MEMORANDUM

TO: District of Columbia Board of Zoning Adjustment
FROM: Arthur Jackson, Development Review Specialist
Joel Lawson, Associate Director Development Review
DATE: April 22, 2014
SUBJECT: **BZA Case 18741** – request for special exception relief under § 214 to continue the existing accessory parking facility on an alley lot located across from 4422 Connecticut Avenue NW

Figure 2

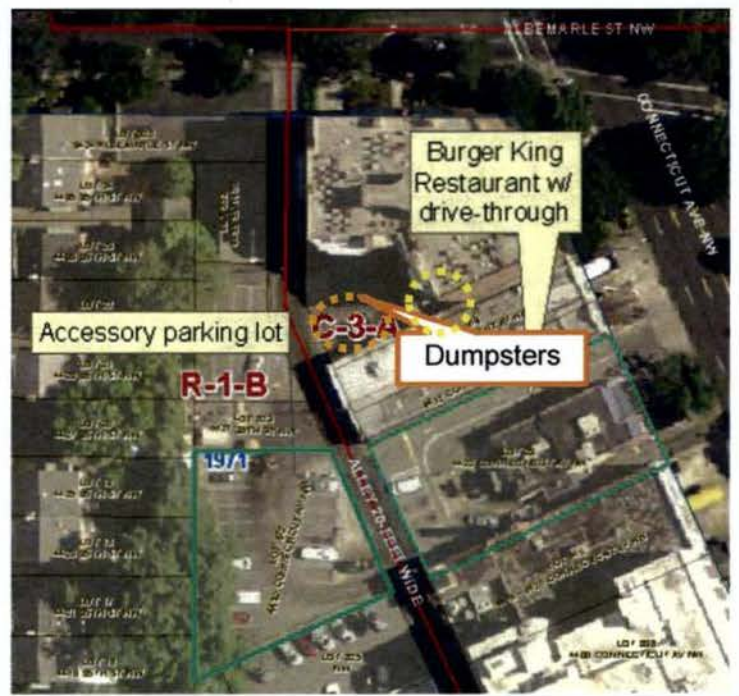
- Approval condition # 2 required removal of two dumpsters in the parking area (refer to the orange oval on Figure 2). The BZA determined that dumpsters on a parking facility in a residence district violated § 2303.1 (c) under which “... no structure other than an attendant's shelter shall be erected or used upon the premises unless the use or structure is otherwise permitted in the district in which the parking lot is located.”

The applicant's Statement originally stated that “... there is no other feasible location for the dumpster.” OP suggested converting 2 parking spaces in the southwest corner of the Burger King lot (the yellow circle on Figure 2) into a dumpster pad, possibly by constructing a retaining wall, filling-in this space and paving it over.

In response, the applicant agreed to relocate the existing dumpsters across the alley onto the Burger King site.
